**FOOD LION - ROCKWALL**  
AN ADDITION TO  
THE CITY OF  
ROCKWALL, ROCKWALL CO.,  
TEXAS  
E. TEAL SURVEY, ABST. NO 207  
SEPTEMBER, 1990

## REVIEW OF THE SITE PLAN FOR FOOD LION STORE

RE: Food Lion Site Plan

**Agenda Item:** P&Z 09-23/SP/PP - Discuss and Consider Approval of a Site Plan/  
Preliminary Plat/Building Plan for Food Lion Grocery Store

| SITE PLAN |            |

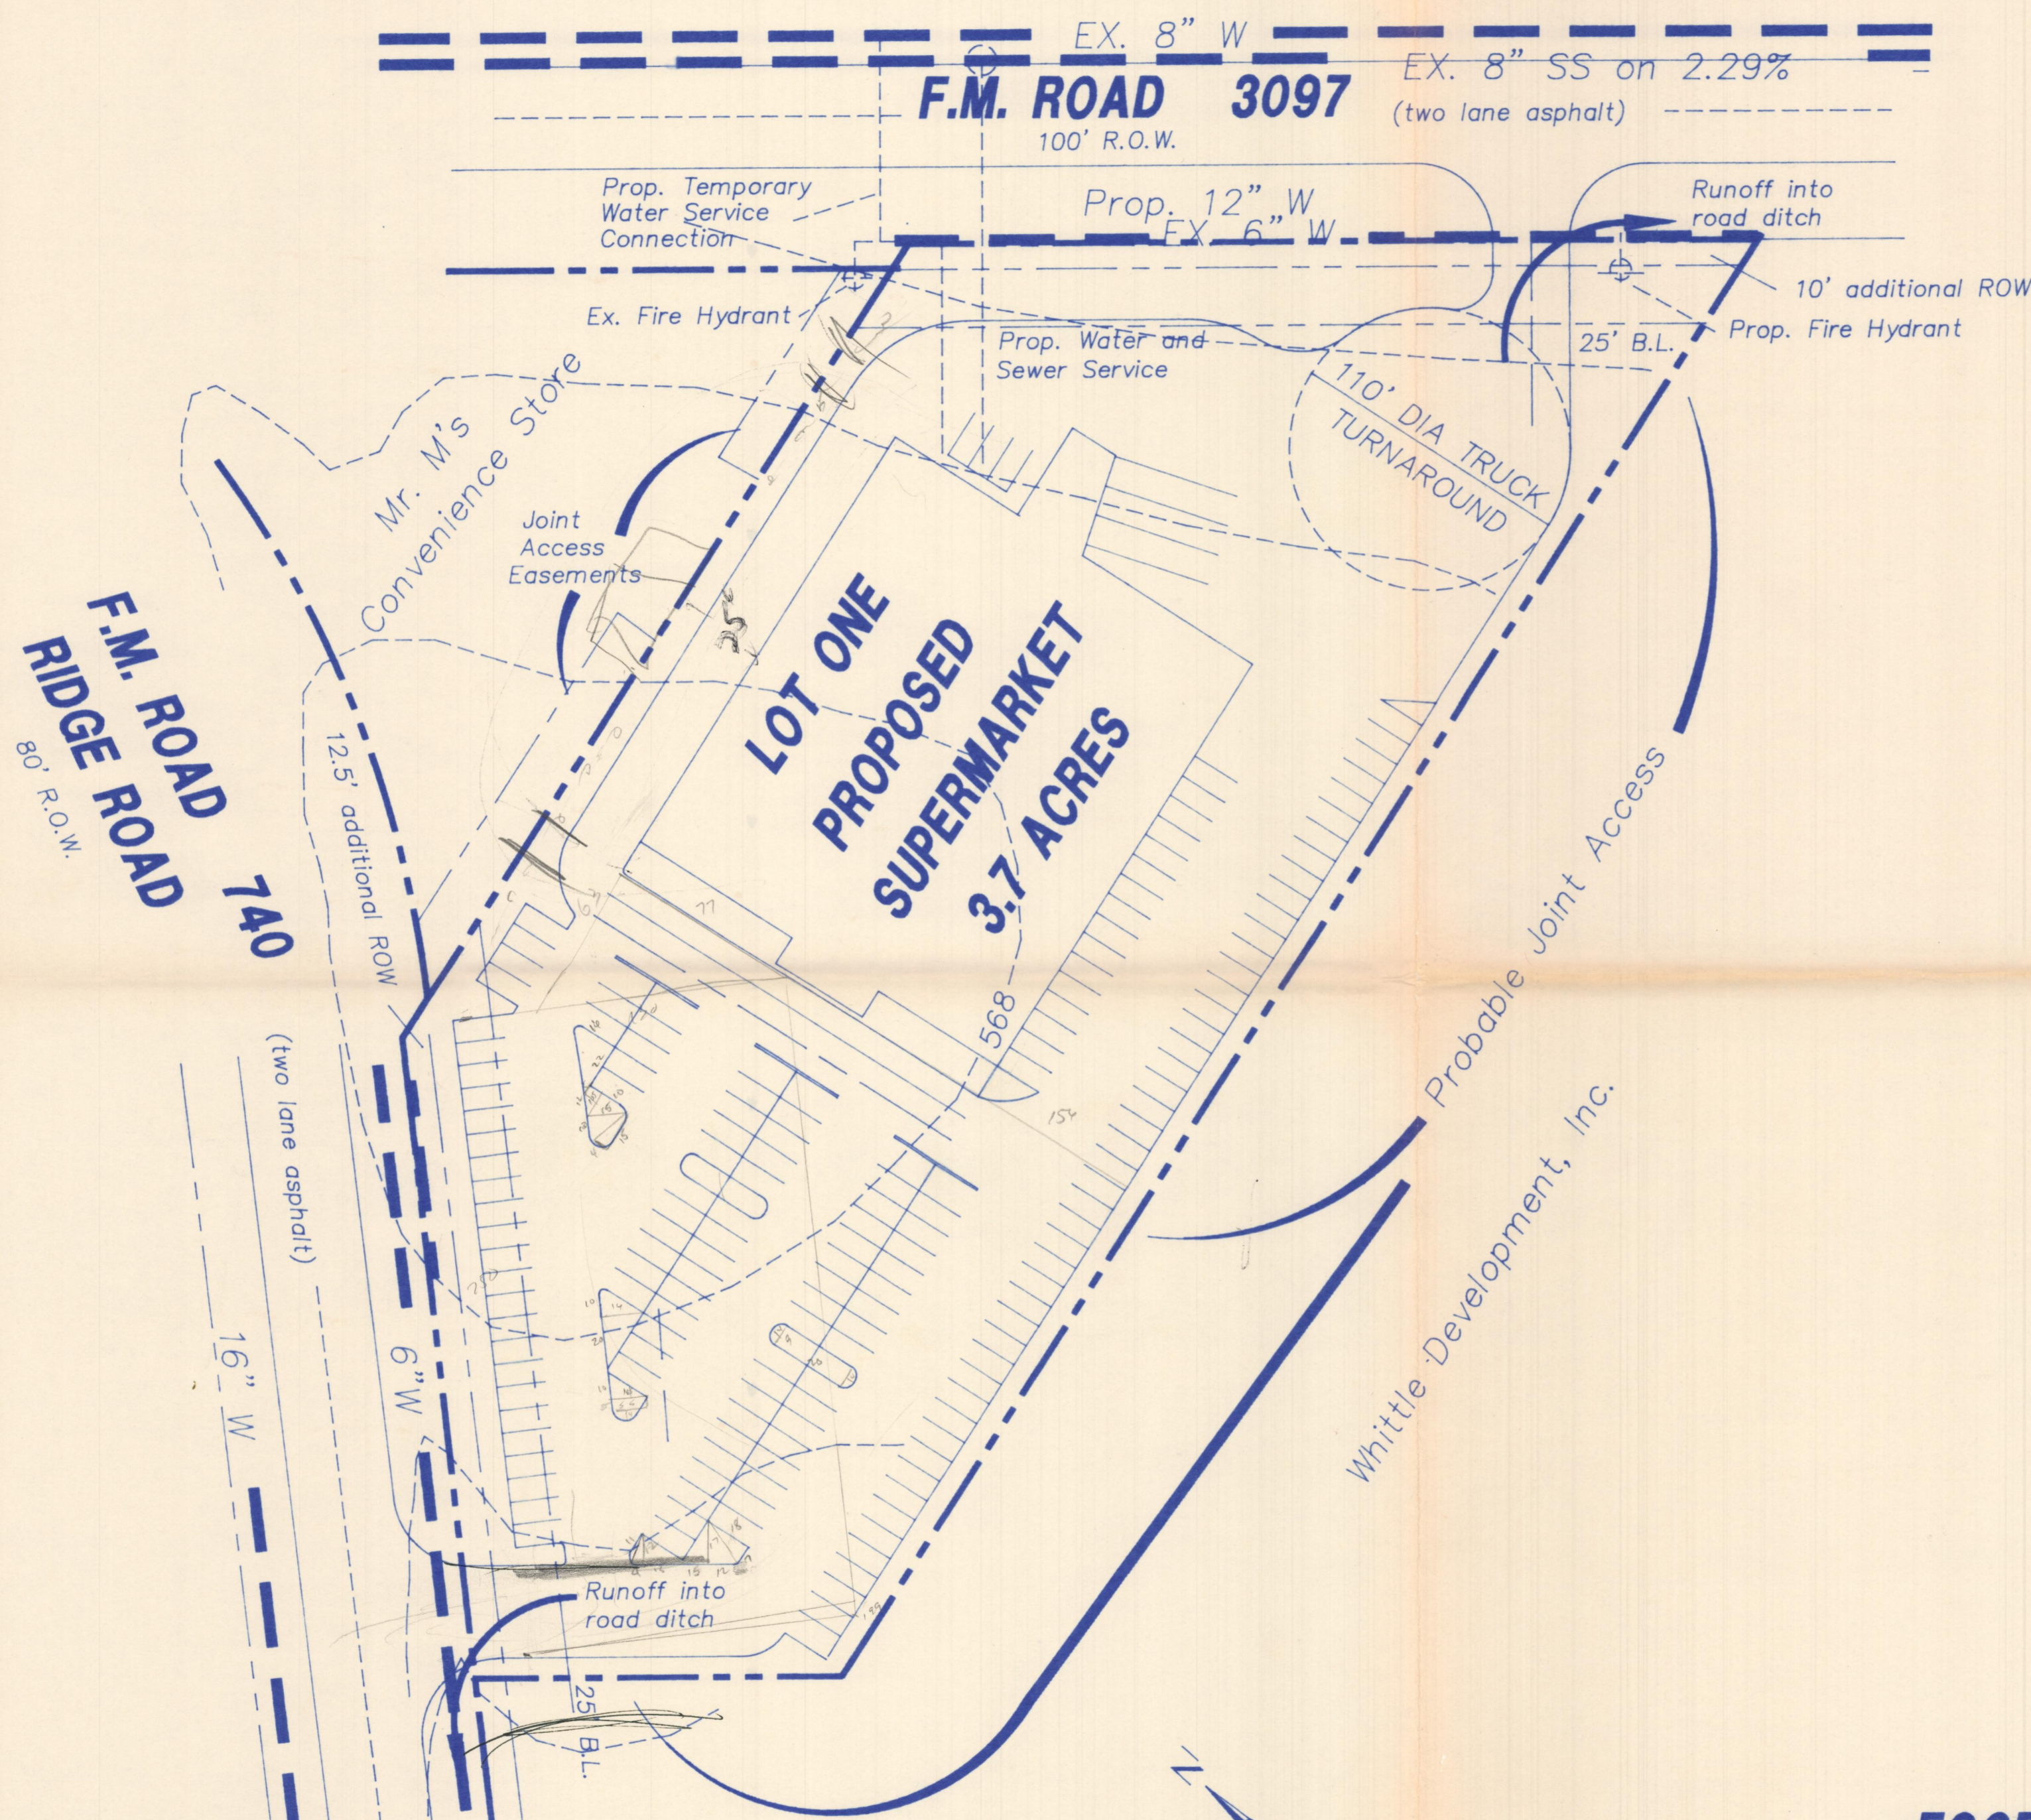
1. Label all dimensions including driveway widths, drive lanes, turning radii, property lines, and building size and dimensions including height.
2. Typical design of all signage including wall and free standing signage. You are limited to a monument sign for a free standing sign design.
3. Location, screening, and dimensions of trash disposal area.
4. Number of parking spaces required and number provided on the site plan.
5. Fire lane needs to be designated.
6. Paving needs to be constructed to the property line at those points that are to be designated as cross access locations. I have identified several possible locations on the attached drawing.
7. Identify paving material.
8. The drive on FM-740 appears to be approximately 35-40 feet. Our general standard for automobile access is 30 feet.

12. Be aware that all utility drops must be underground.
13. You are providing 12.5 feet of ROW on FM-740. Our current plans only call for 7.5 feet to be dedicated.

14. As indicated on the Overlay District Site Plan application we need grade information on the access drives and cross section information through the building and site.

**A FRONT ELEVATION**  
1/8" = 1'-0"

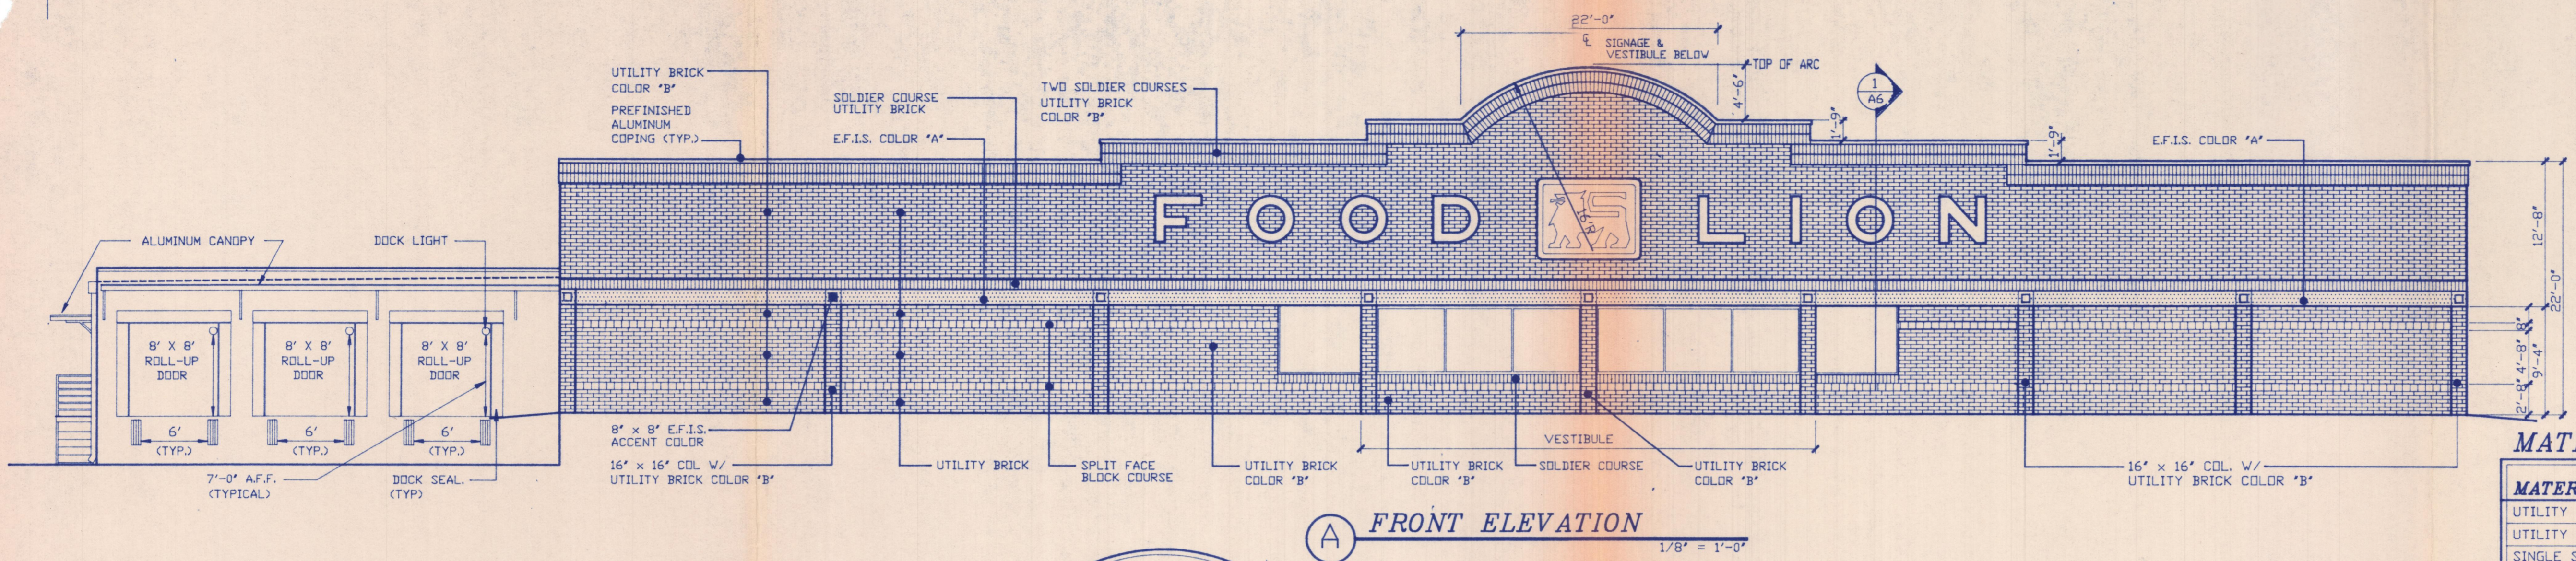
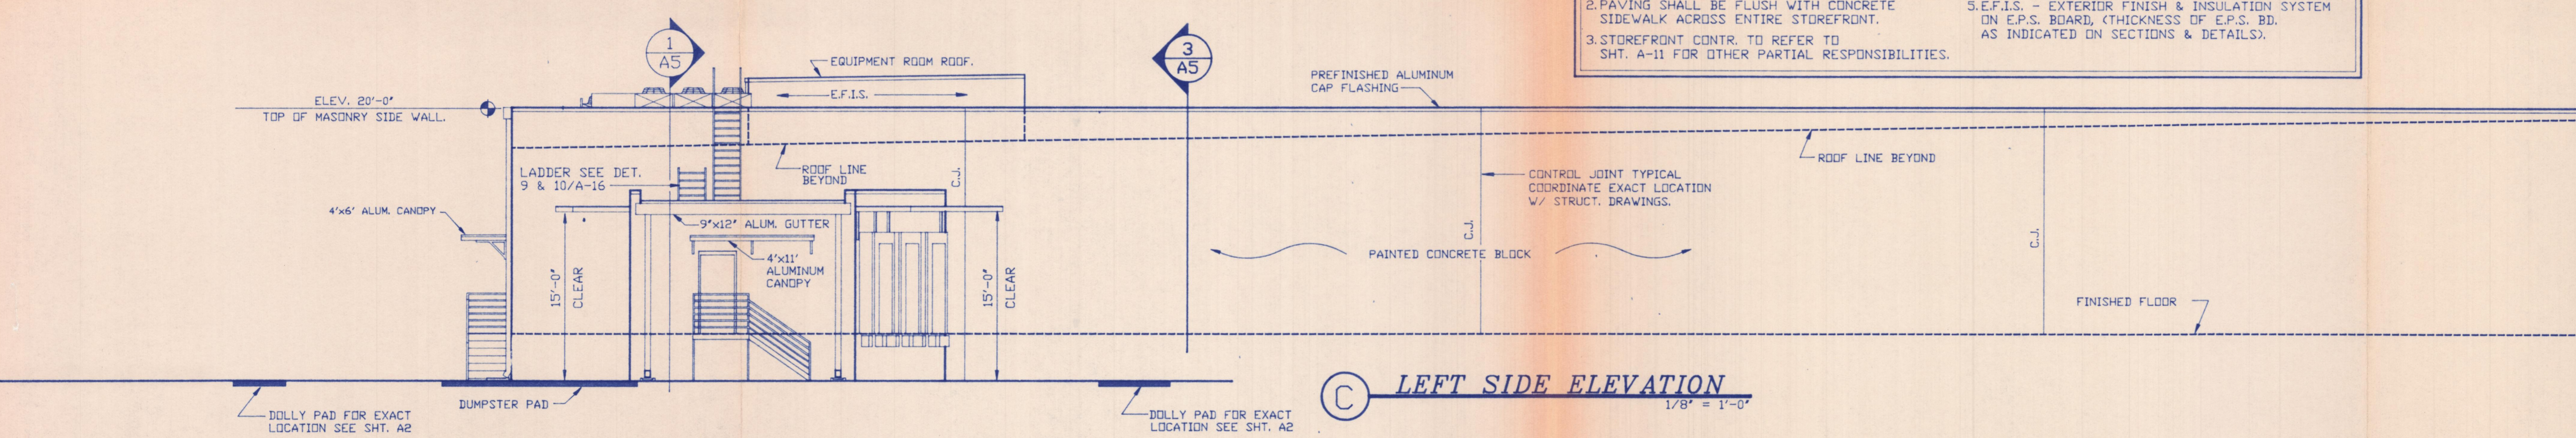
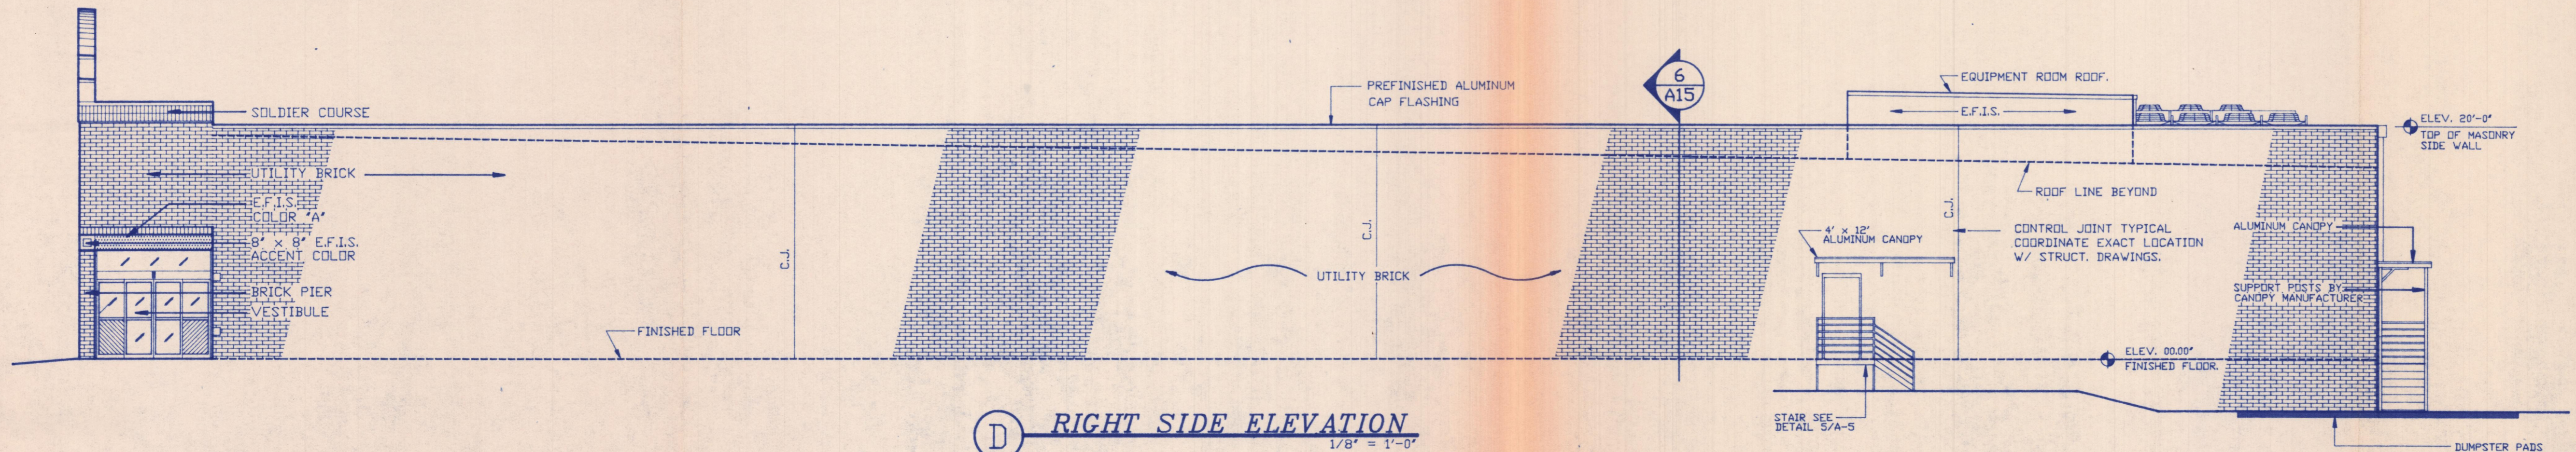
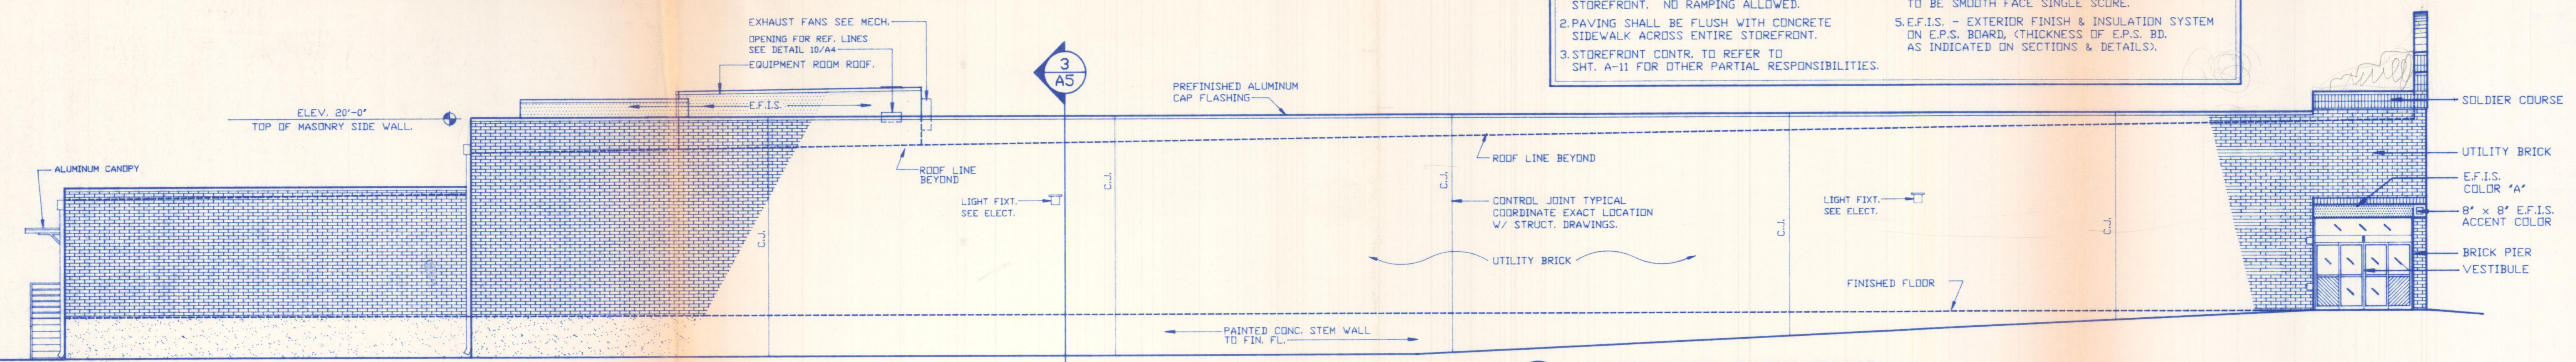
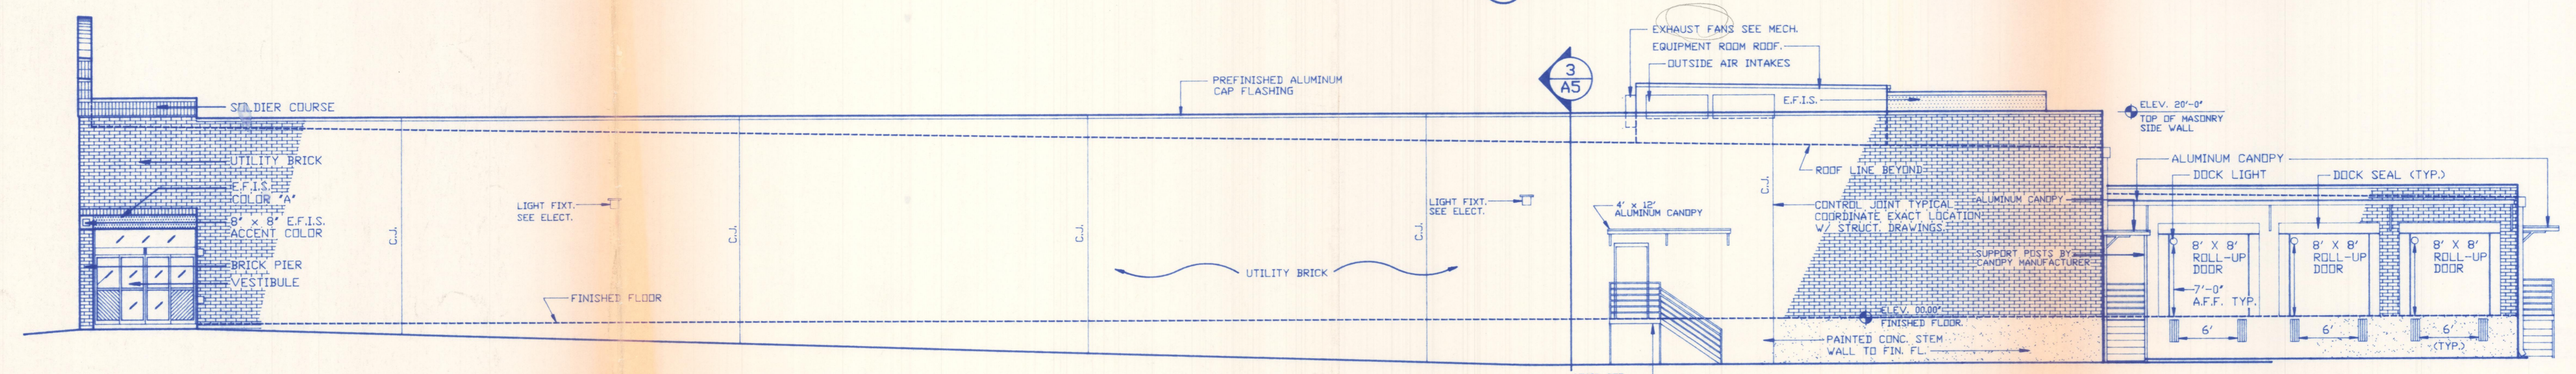
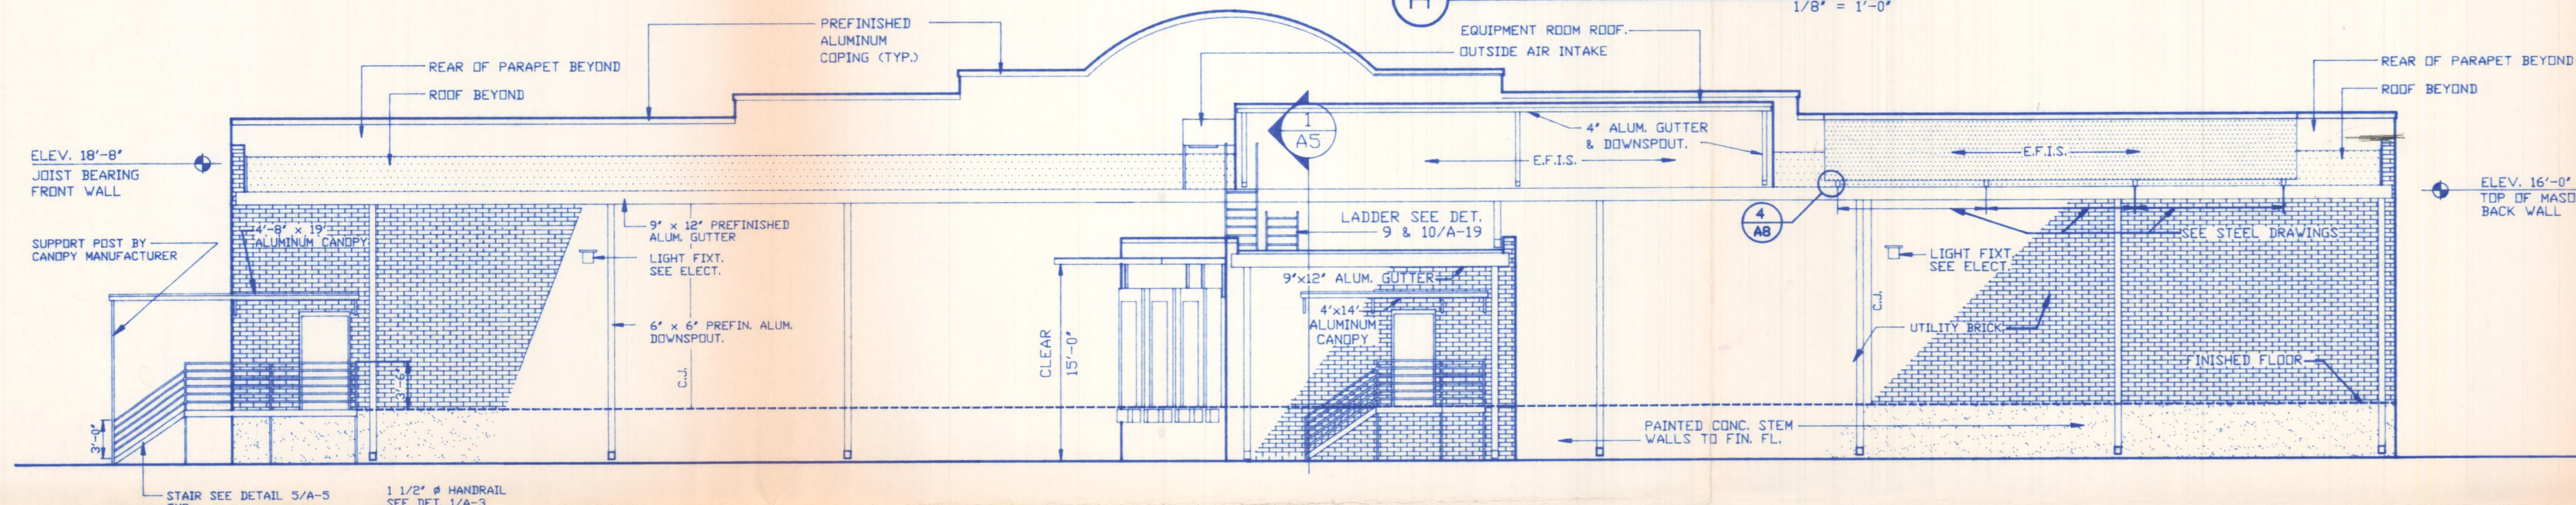
9. The parapet at the two front corners of the building should be wrapped around from the front to the sides to add some mass and break up the visual appearance of the front parapet.

8. The parapet wall should be extended along the back of the building.
9. The parapet at the two front corners of the building should be wrapped around from the front to the sides to add some mass and break up the visual appearance of the front parapet.

The developer has removed the stucco type screen and has extended the parapet along the back of the building. This change is reflected in the revised elevations. As a point of information, the parapet is not as high as the screen was proposed to be and the top of the mechanical equipment is visible over the top of the parapet.

The developer had some initial concerns about this issue, but they believe it can be addressed. The elevations do not reflect this change, but they hope to have a proposed solution by Monday.

The developer has no problem with this and the bands are now reflected on the revised elevations.
